ADDENDUM NUMBER FIVE**Issued: 2 February 2023****Bid Date: 14 February 2023 at 3:00 PM**

ARCHITECTURAL A400 ENLARGED DRAWINGS – VEHICULAR GATES

GULF COAST CENTER FOR ECOTOURISM & SUSTAINABILITY
 SITE & CIVIL PACKAGE
 GULF SHORES, ALABAMA

FLITCH PLATE DETAIL AXON 9

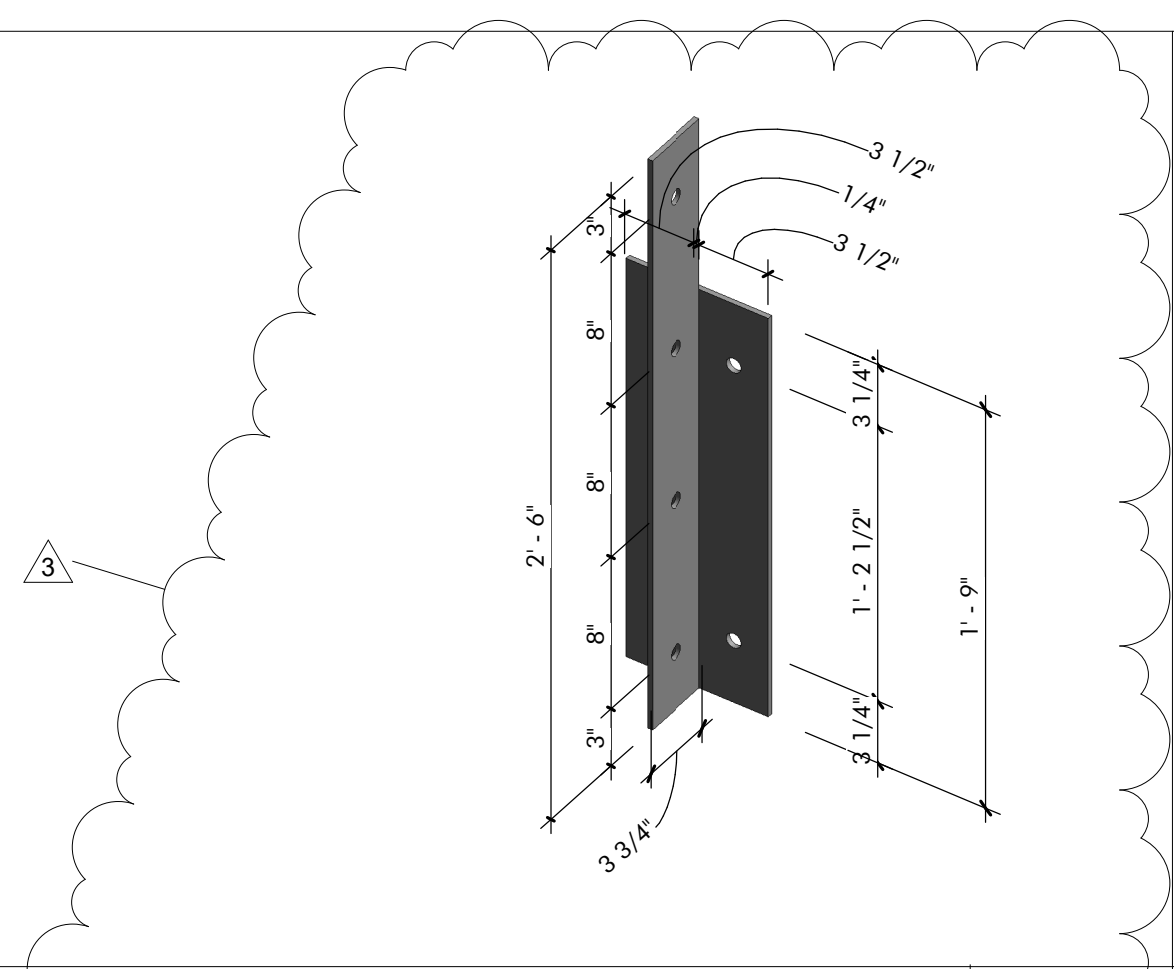
2. Reference same drawing package, same Detail 3/A400. Please provide a detail of the Galvanized steel flitch plate that occurs at each double 2x4 fence posts.

- Added detail 9 for the galvanized steel flitch plate.

Response: Refer to revised sheet A400 of the Site & Civil Package, drawing 7, for isometric detail of galvanized steel flitch plate to be used at double 2x4 posts.

ENLARGED SECTION SCREEN WALL 3

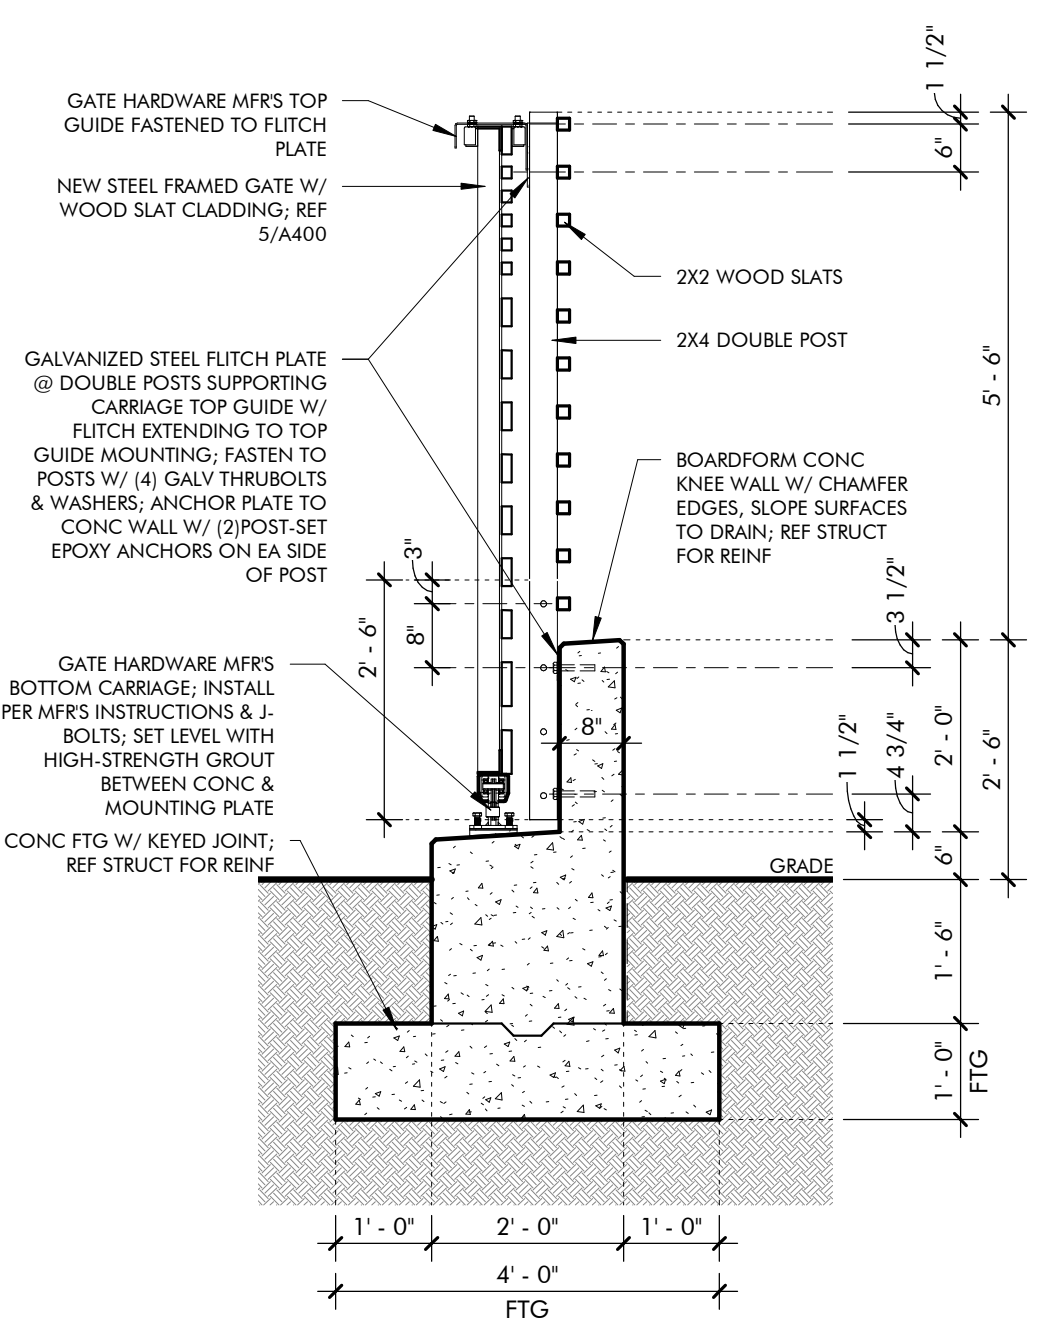
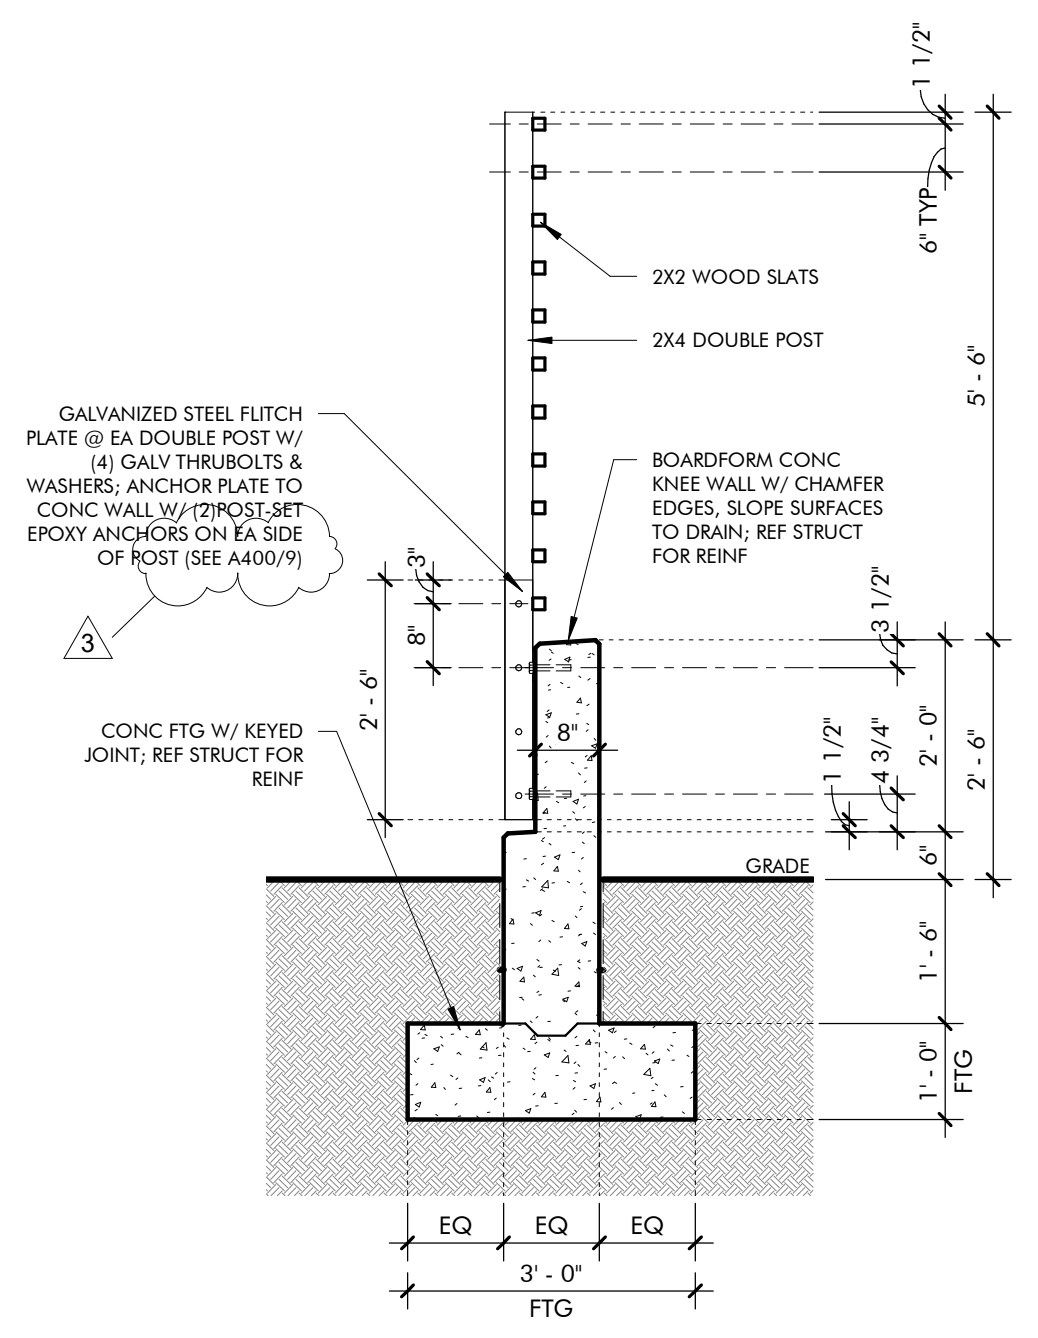
1. Reference Site and Civil drawing package, Detail 3/A400 -Enlarged Drawings Vehicular Gates. Please confirm that the structural footing/kneewall occurs along the entire deer fence perimeter of the site.

Response: The concrete footing and kneewall is located only as shown in drawing 1 on sheet A400 of the Site & Civil Package. Drawing 1 details the main vehicular entrance gate adjacent to the Welcome Hub. Note that the wood screen wall extends from the plan east of Drawing 1 and continues into the Welcome Hub Package, but is of similar construction and assembly. Refer sheet AW100 of the Welcome Hub Package.
